Notice of concurrence agency response
Sections 3.3.16 and 3.3.18 *Integrated Planning Act 1997*

Re: Application (No. DA:764/1) for development approval for assessable development to be carried out at Cnr Mt Kilcoy Road and Kilcoy -Murgon Road (Lot 1 on CG1971).

PROJECT
PROPOSED RECONFIGURATION OF LOT 1 ON CG1971

PLAN No A3/35422/PROP Amdt

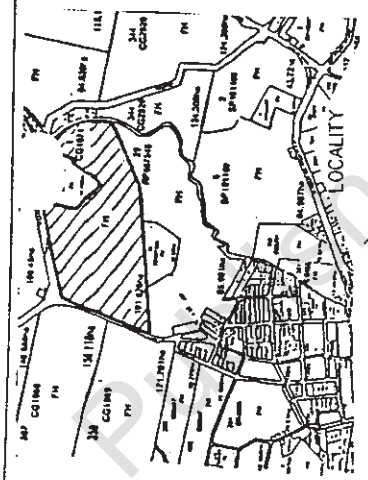
1. The reconfiguration must be in accordance with the survey plan of Lot 1 on plan CG1971 plan number A3/35422/PROP prepared by Murray and Associates (QLD) Pty Ltd dated 19/12/02.

2. It is a requirement that the applicant notify the Environmental Protection Agency (EPA) (Contaminated Land Unit) in writing within 5 working days of the survey plan being endorsed and provide a copy of the registered plan to the EPA (Contaminated Land Unit) to enable: (i)the removal of proposed Lot 1 from the Environmental Management Register (EMR).

Proposal: **The applicant is seeking DA for Reconfig to create 2 parcels both greater than 40 ha in area. A cattle dip exists on the proposed Lot 1 and is approximately 200m from the proposed Lot 2 and approximately 700m from the nearest existing boundary. The cattle dip is a continuing use.**

Considering the relative distances between the existing dip and the proposed lot 2 and the fact that the dip is a continuing use it is recommended to issue a concurrence response with the following conditions:

FIELD -	FB -
DRAWN CRA	LD -
CHECKED BLA	Comp Job No. 35422
Date 19/12/02	Orig Job No. DWG35422
Scale 1:7500	
PLAN No A3/35422/PROP	Amdt /

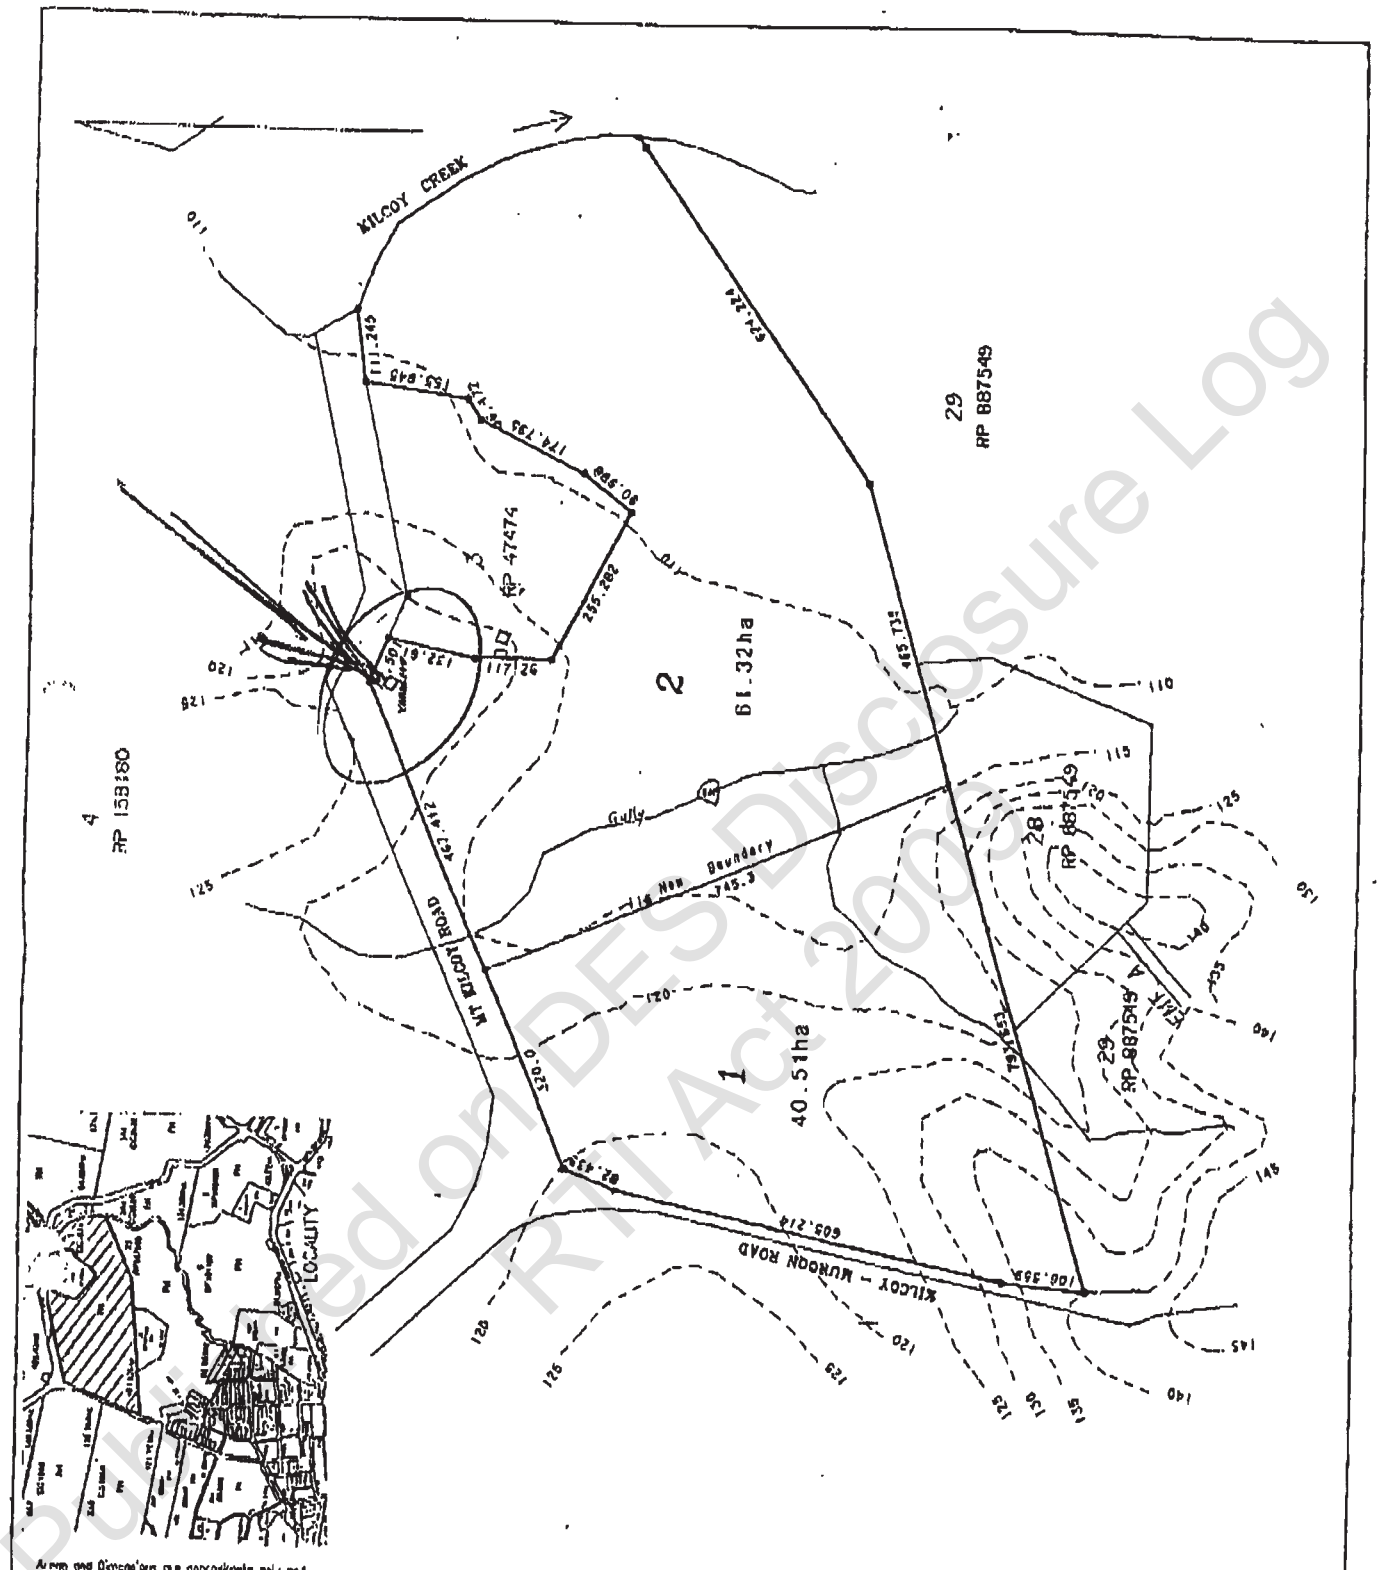
b) A survey plan indicating the location of the livestock dip in relation to current and proposed lot boundaries.
